**Maine Maritime Academy  
Castine, Maine**

**Pier Upgrades and Waterfront Improvements Project  
March 22, 2024  
ADDENDUM NO. 6**

Fig. 5.2b—Class 1 protection: encapsulated bar anchor.

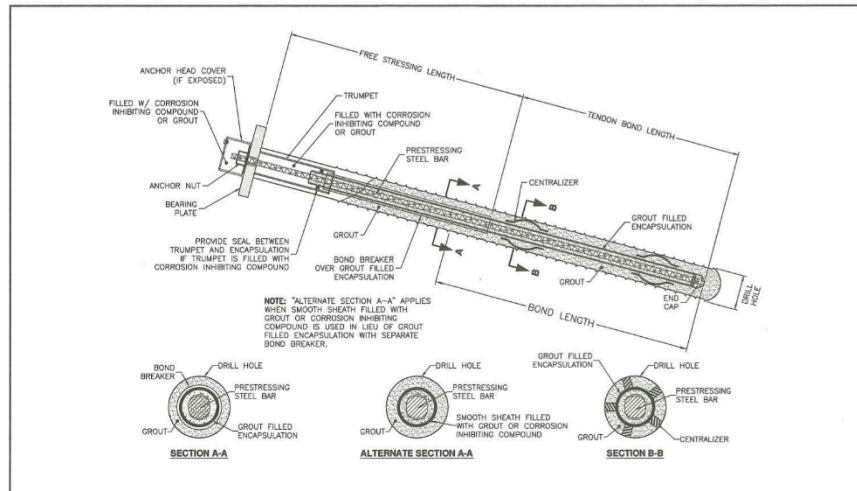
- Please confirm the corrugated grout sheath for Class 1 Anchors can be omitted above the bond length (PTI Fig 5.2b – Class 1 protection Alternate section A-A)

Response 37-D: Grout is not required outside of the PVC sheath within the unbonded zone.

GRADING & UTILITY PLAN B

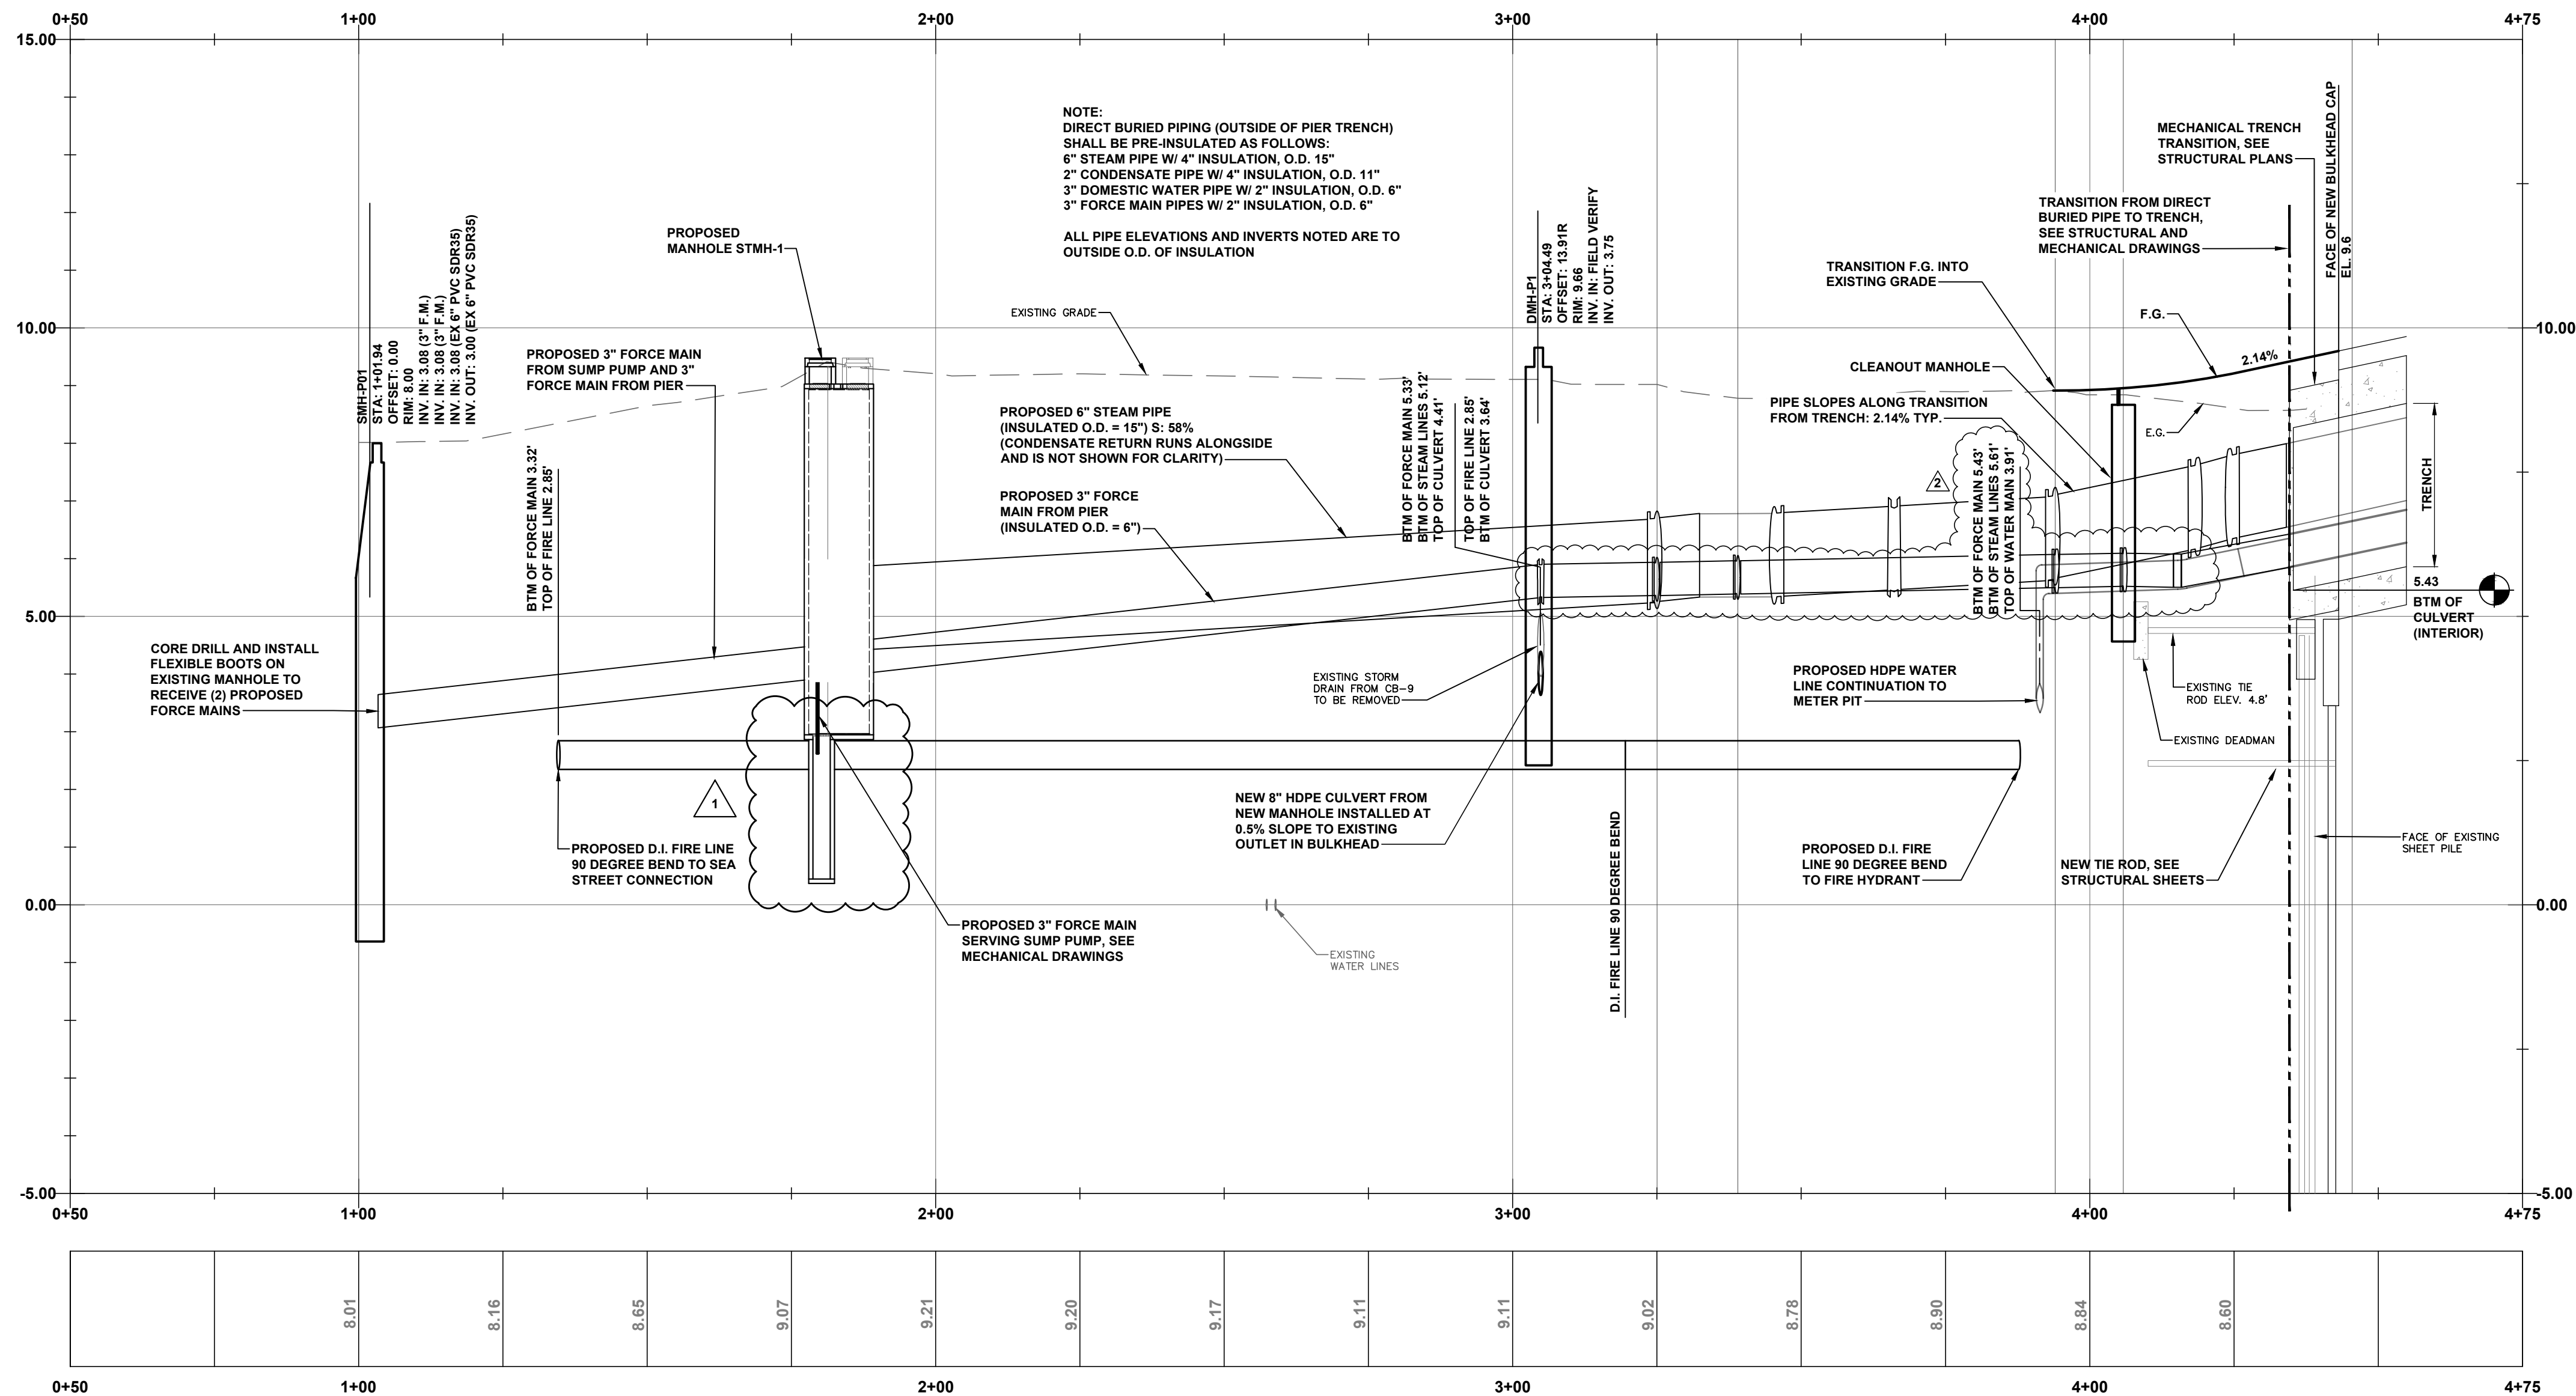
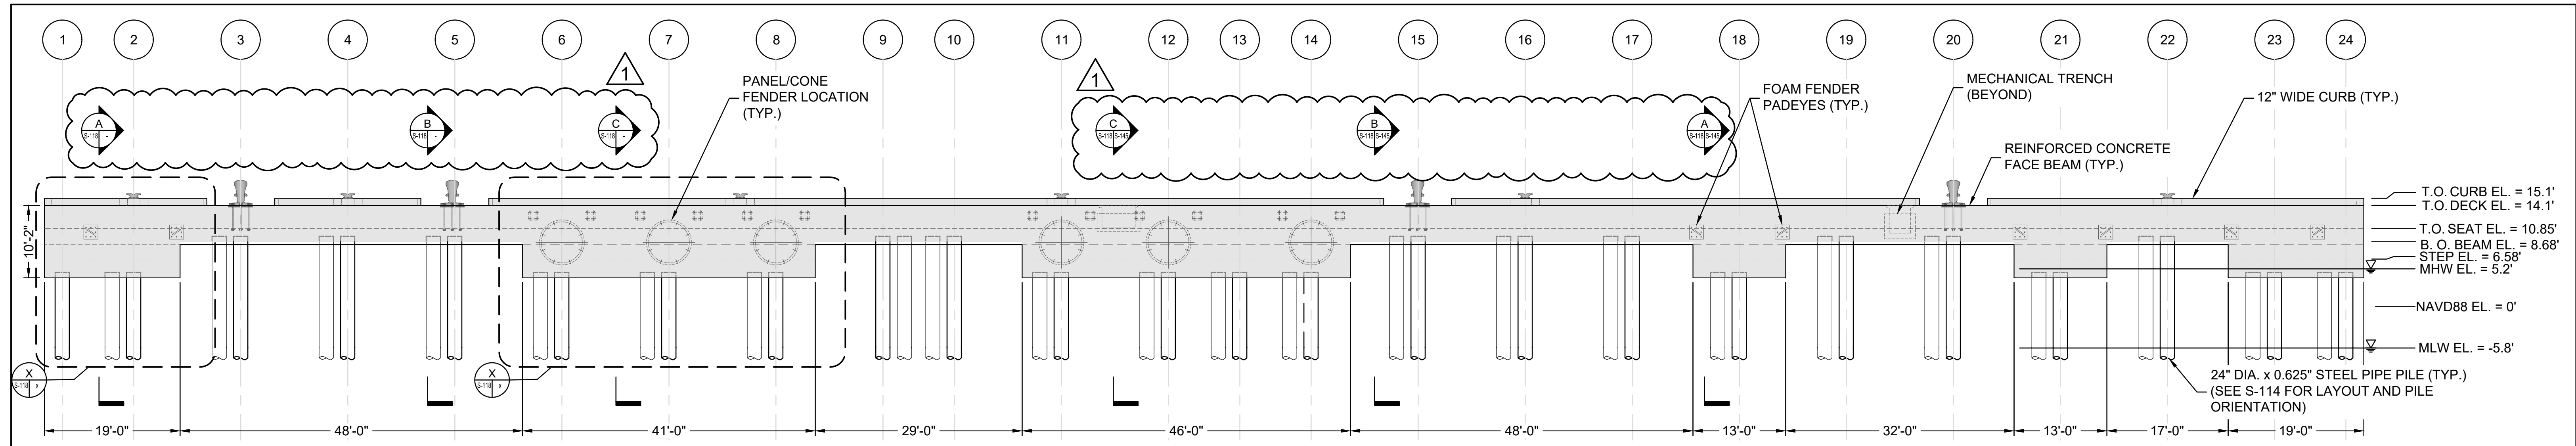
14. IFB C-201: The proposed 3" HDPE insulated forcemain pipe is indicated to be heat traced. The heat trace for this piping does not appear on the heat trace schedule on drawing M-801. Please advise.

Response 14: The heat trace is not needed on the direct buried pipe. See attached re-issued Drawing C-2-2 for modifications to the vertical alignment of the sewer forcemain.

**SHEET E-201 NUMBERED ELECTRICAL NOTES**

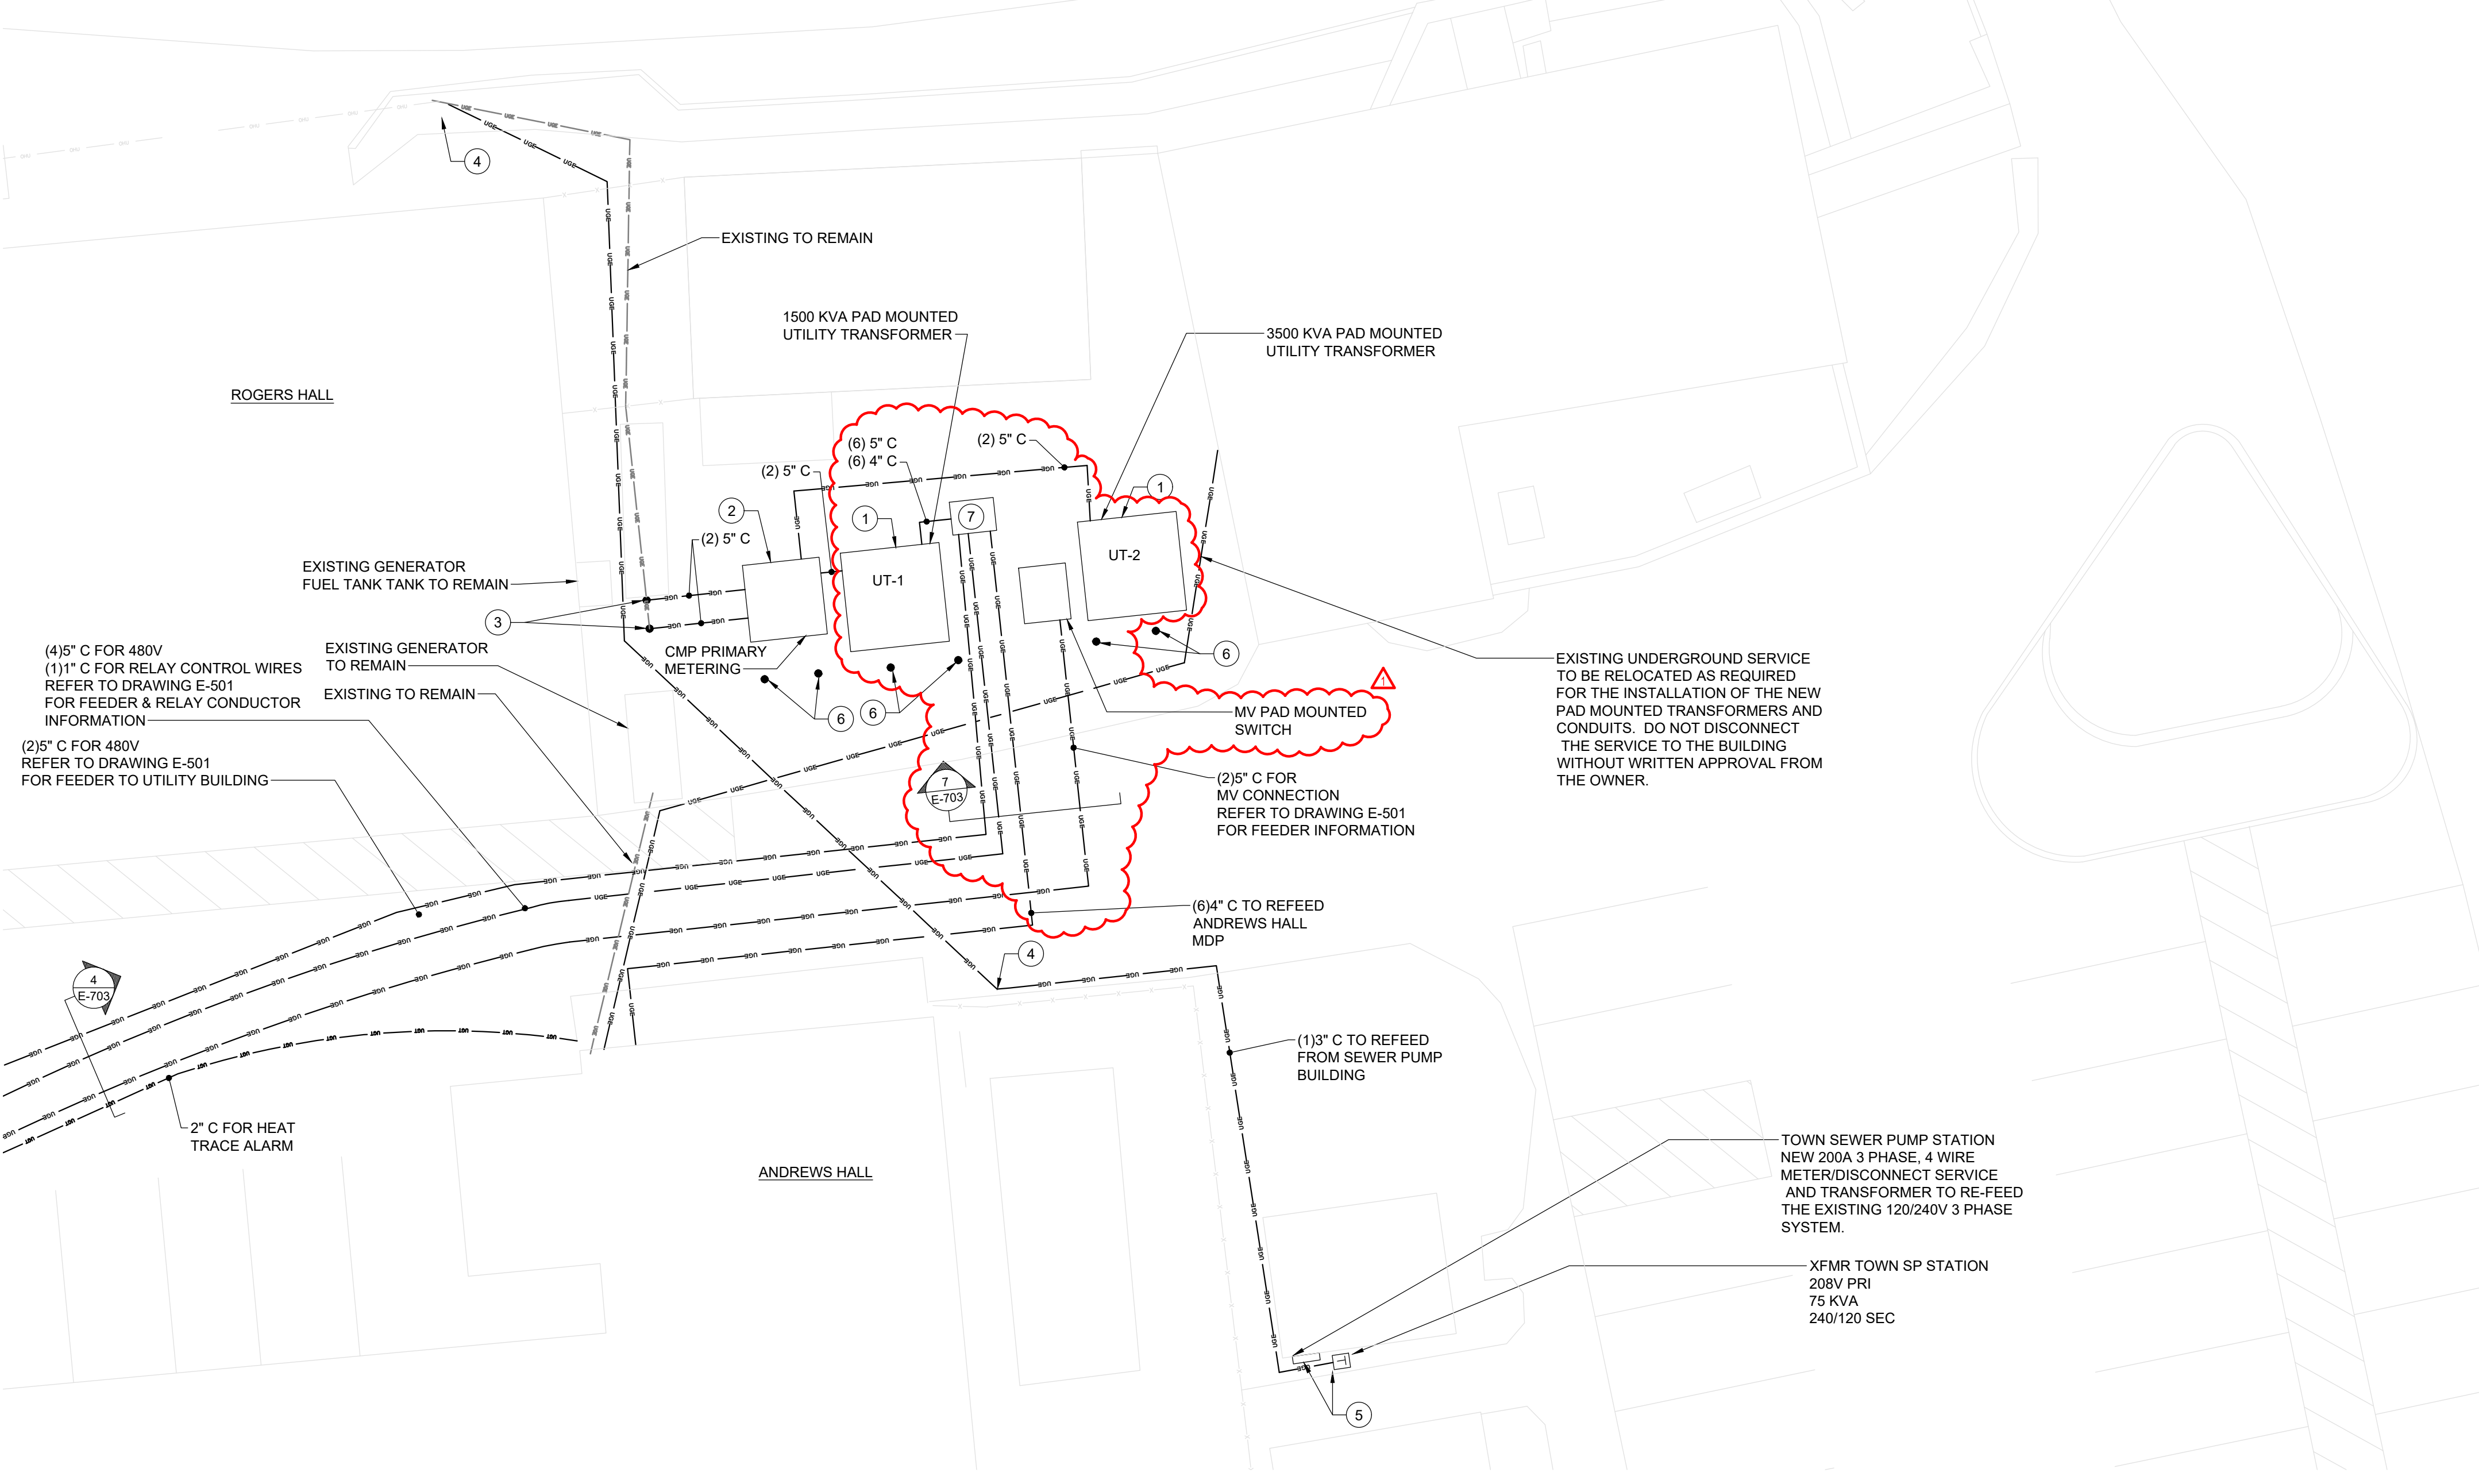
21. IFB E-201 / E-501: Sheet E-201 Numbered Electrical Notes #7 requires a 3'x4' enclosed disconnect switch for the secondary breakers in stainless steel NEMA 3R Enclosure. This disconnect and its configuration does not appear to be indicated on E-501. Please incorporate the disconnect switch on E-501 and provide additional details for amperage rating and fusing if required.

27. IFB E-501: there is a enclosure listed for secondary breakers after the UT-1 transformer, on print E-201 numbered note 7 indicates a 3'x4' enclosed disconnect switch for the secondary breakers in stainless steel NEMA 3R enclosure. After going through Sections 26 05 33.16 Boxes for Electrical Systems, 26 24 16 Panelboards, 26 28 16.16 Enclosed Switches, and 26 43 00 Surge Protection Devices in the specs, more information is needed to provide the desired product. Can you provide more information on the secondary breakers?

Response 21: See the attached re-issued IFB Drawing E-201.

Response 27: See the attached re-issued IFB Drawing E-201.

6. CONTRACTOR SHALL PROVIDE PROTECTIVE BOLLARDS IN FRONT OF THE NEW ELECTRICAL EQUIPMENT.
7. PROVIDE CUSTOM STAINLESS STEEL ENCLOSURE TO HOUSE THREE (3) GROUPED DISCONNECTS. DISCONNECT RATINGS SHOWN ON DRAWING E-501.
